Response to Submissions Report
New Primary School at Googong
SSD-10326042

On behalf of
NSW Department of Education
September 2021

Figure 1: Updated site plan (Source: Pedavoli Architects)

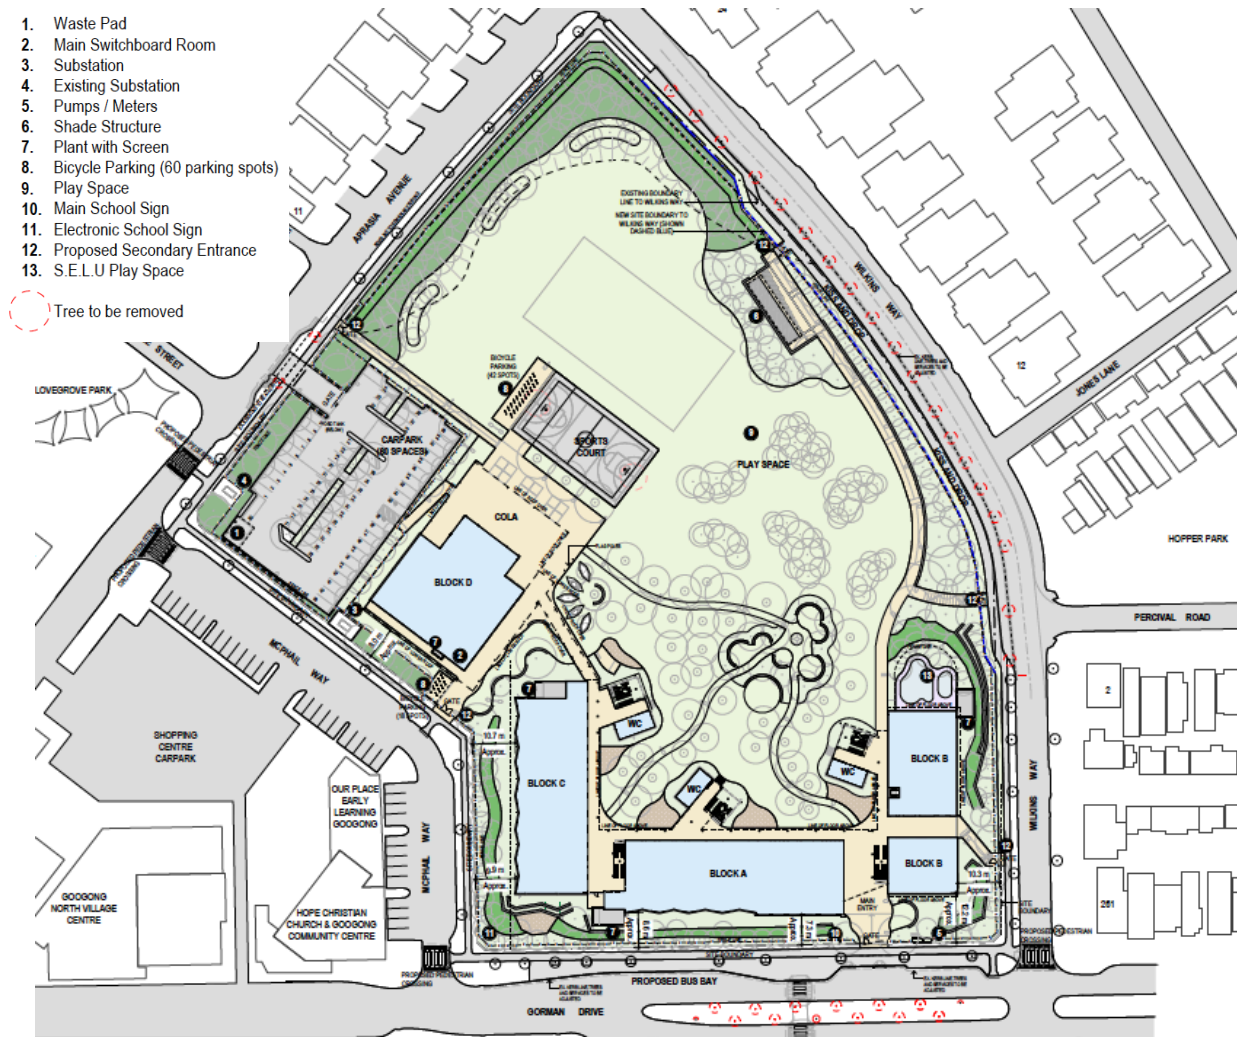
Proposed change	Reason for change
1. Primary kiss-and-ride area moved to Wilkins Way	This change was made in direct response to Council's submission. Refer to section 2.1 below for further detail.

Proposed change	Reason for change
2. Special Education Learning Unit (SELU) kiss-and-ride on Gorman Drive converted to two 15-minute parking spots and two disabled parking spots	After consultation with relevant stakeholders, it was decided that SELU kiss-and-ride is not operationally viable. SELU students will be encouraged to use the kiss-and-ride on Wilkins Way, and the spaces along Gorman Drive will only be used when required. Refer to section 2.2 below for further detail.

3. Two pedestrian crossings on Gorman Drive changed to one mid-block crossing	Change made in response to Council comment. Refer to section 2.3 below for further detail.

4. Car park layout altered to set gate further inside site boundary. Waste pad also relocated	Changes made to meet Australian Standards and to improve waste collection. Refer to section 2.4 below for further detail.

5. Digital pylon sign relocated to corner of Gorman Drive and McPhail Way.	Change made in response to Council's concern of electronic signage facing residential properties. Refer to section 2.5 below for further detail.

An updated site plan is shown in the figure below.

Figure 2: Revised kiss-and-ride location (Source: Pedavoli Architects)

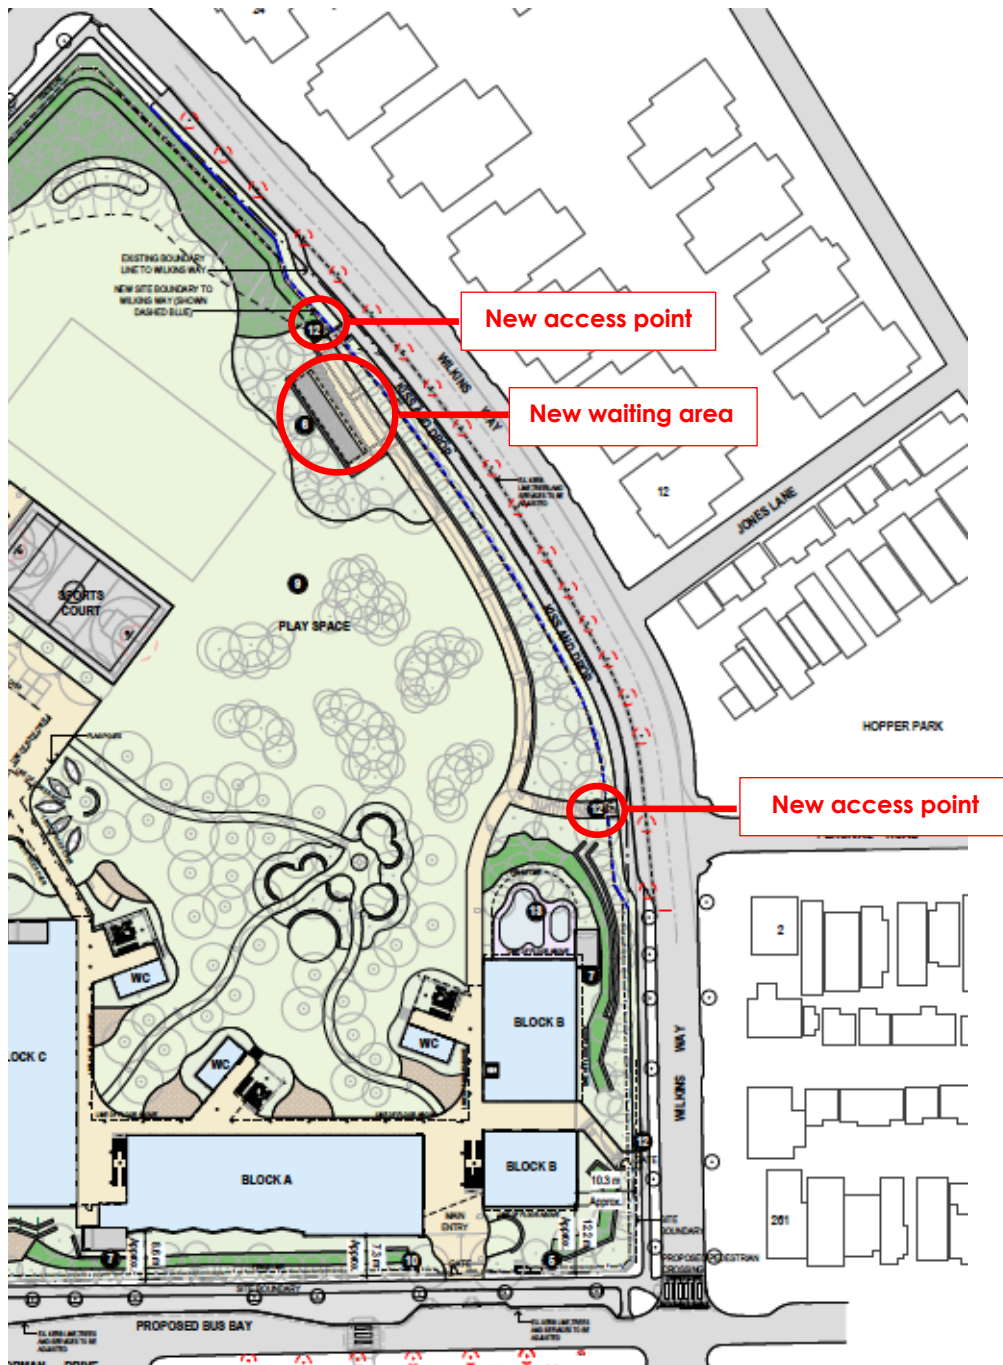
In its submission, Council advised it did not support the location of the kiss-and-ride along Aprasia Avenue primarily due to issues associated with the narrow width of the road. Council recommended that the kiss-and-ride be relocated to along Wilkins Way (first preference) or within the site (secondary preference). The project team met with Council officers twice following receipt of Council's submission to discuss this matter along with other issues.

Following discussions with Council, the kiss-and-ride area has been relocated to Wilkins Way, consistent with Council's recommendation, as shown in the figure below. The relocated kiss-and-ride will require slight widening of Wilkins Way. The public domain plan at Appendix 7 of the RTS identifies the extent of the works.

The new kiss-and-ride area has 21 bays.

As seen in the figure above, the updated design includes a new pathway, two new access gates and a waiting area with shade shelter along the Wilkins Way frontage.

Figure 3: Parking along Gorman Drive (Source: Pedavoli Architects)

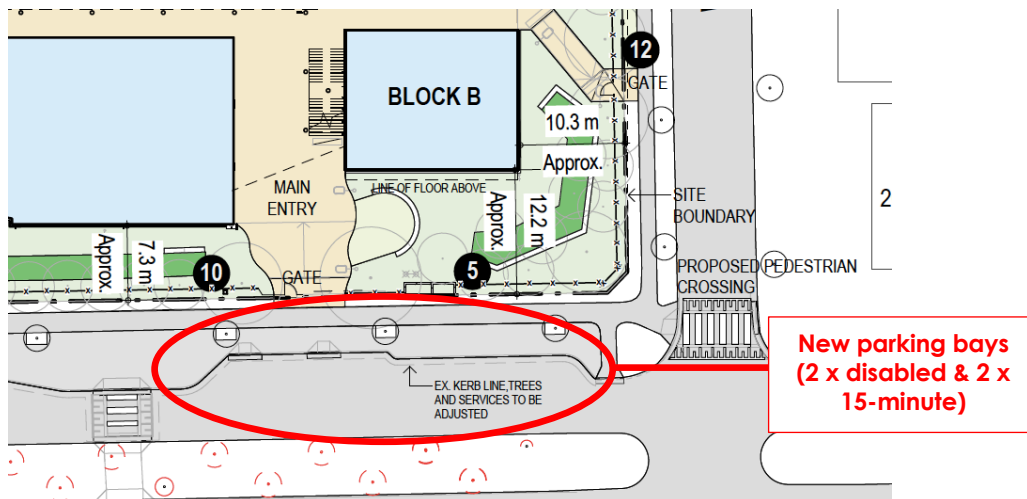
After consultation with relevant stakeholders, it was decided that SELU kiss-and-ride is not necessary or operationally viable, and therefore a separate SELU kiss-and-ride area (originally provided along Gorman Drive) has been removed and replaced with two disabled spaces and two 15-minute parking spaces, as illustrated in the figure below.

SELU students will be encouraged to use the kiss-and-ride on Wilkins Way, and the parking spaces along Gorman Drive will only be used when required.

Figure 4: Parking along Gorman Drive (Source: Pedavoli Architects)

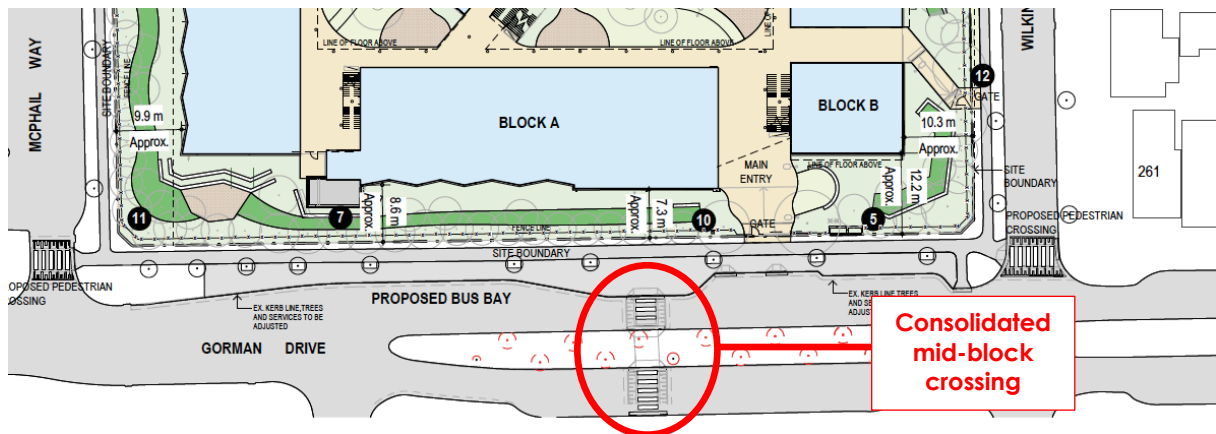
In its submission Council advised it did not support the number of pedestrian crossings and recommended that the number of crossings be minimised.

In response, the two crossings at either end of the Gorman Drive frontage have been replaced with a single mid-block crossing, as illustrate in the figure below. The location of this crossing was supported by Council officers at a meeting on 9 September 2021.

The mid-block crossing will require removal of Trees 91 to 99 inclusive as identified in the updated Arboricultural Impact Assessment Report at Appendix 5 of this RtS. The trees are all young London Plane trees, each with a canopy spread of approximately 2-3m. The project team considers the tree removal to be acceptable given it will accommodate a pedestrian crossing in a location supported by Council officers.

Figure 5: Modified car park layout (Source: Pedavoli Architects)

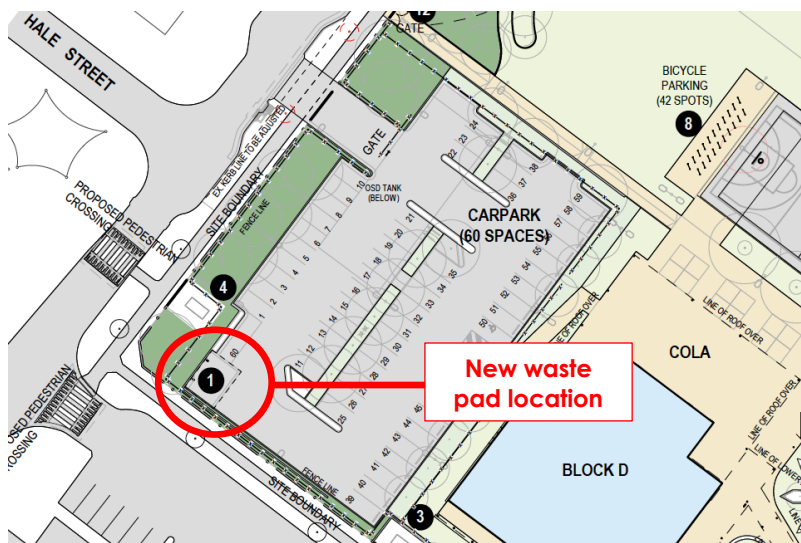
The car park layout has been modified slightly as follows:

- The gate has been set back to ensure the carpark is compliant with Australian Standards, allowing for a two-car queuing space.
- The waste pad has been relocated to the northwestern corner of the car park to allow for collection by an 11m front-lifting waste truck.
- The corners of the carpark car park have been “squared off” to allow for appropriate servicing maneuverability.

The total number of parking spaces has been maintained at 60.

Figure 6: Revised digital signage location (Source: Pedavoli Architects)

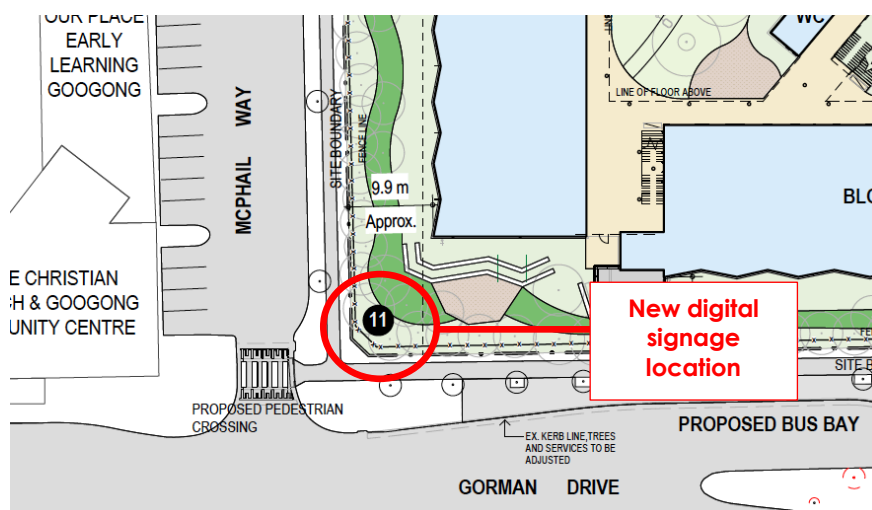
A digital pylon sign was originally proposed at the main vehicular entry along Aprasia Avenue, facing the residential properties across the street. In its submission, Council recommended that any proposed illuminated signage should not face residential properties.

In response, the pylon sign has been moved to the corner of Gorman Drive and McPhail Way so that it faces the commercial development across McPhail Way, as illustrated in the figure below. The design of the signage remains unchanged.
